# Technical Service Bulletin

## 51 Water ingress into the front footwells

51 22 24 2067103/1 May 23, 2022.

Model(s)	Year	VIN Range	Vehicle-Specific Equipment
A8 e quattro	2020 – 2021	All	PHEV

*Figure 1. Location of the plenum chamber bulkhead opening.*

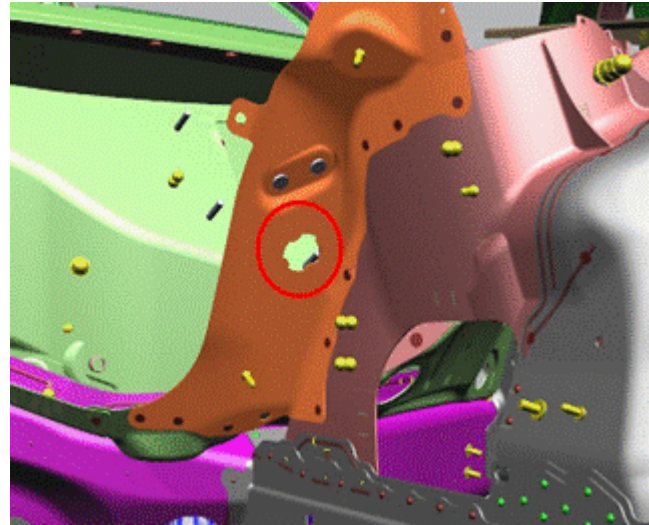
A missing body plug is discovered in the plenum chamber bulkhead causing water intrusion.

The plenum chamber bulkhead provides an opening for a vacuum line on all A8 models (Figures 1 and 2). For A8 TFSI e PHEV models this opening is not used. In the production process of an A8 TFSI e PHEV model, a body plug was to be installed to close off this opening. The body plug may not have been installed in this opening on A8 TFSI e PHEV models only.

Remove the speed nut for the heat shield on the plenum chamber bulkhead and loosen the heat shield to provide access to this opening. Install body plug 4N0 611 817 A in this opening (Figure 3).
